Product Change Notification

113330 - 00

Change Notification #: 113330 - 00
Change Title: Intel® Server System R2308GZ4GC
PCN 113330-00, Product Design
Update the System Rear Panel
Date of Publication: October 23, 2014

Figure One

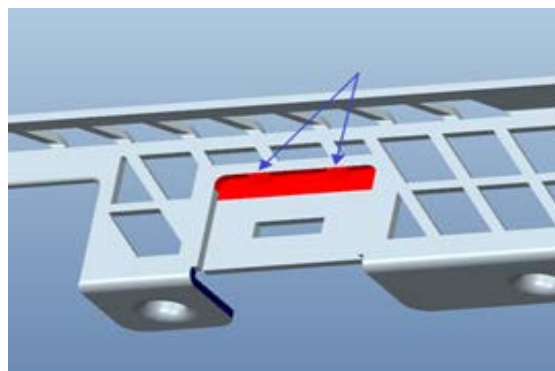
1. Update the one big center joint to two smaller joints so that the joints will not conflict with the LAN cable connector latch. See Figure One.

Figure Two

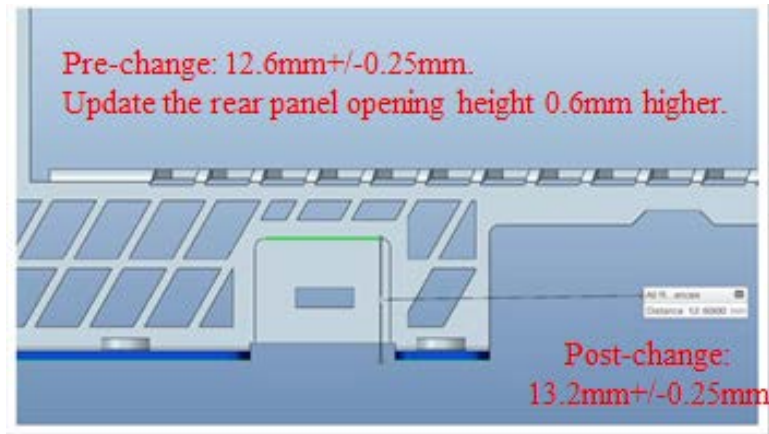
- Update the rear panel opening height 0.6mm higher to improve the flexibility for the cable latch. The previous height was 12.6mm+/-0.25mm. The updated height is 13.2mm+/-0.25mm. See Figure Two.

Figure Three

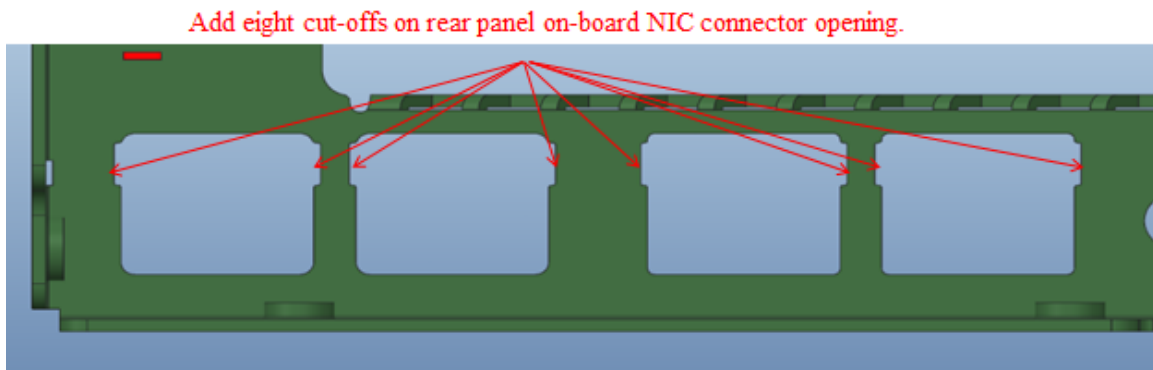
- Add eight cut-offs around the on-board NIC (Network Interface Controller) openings to improve the LED visibility. See Figure Three.
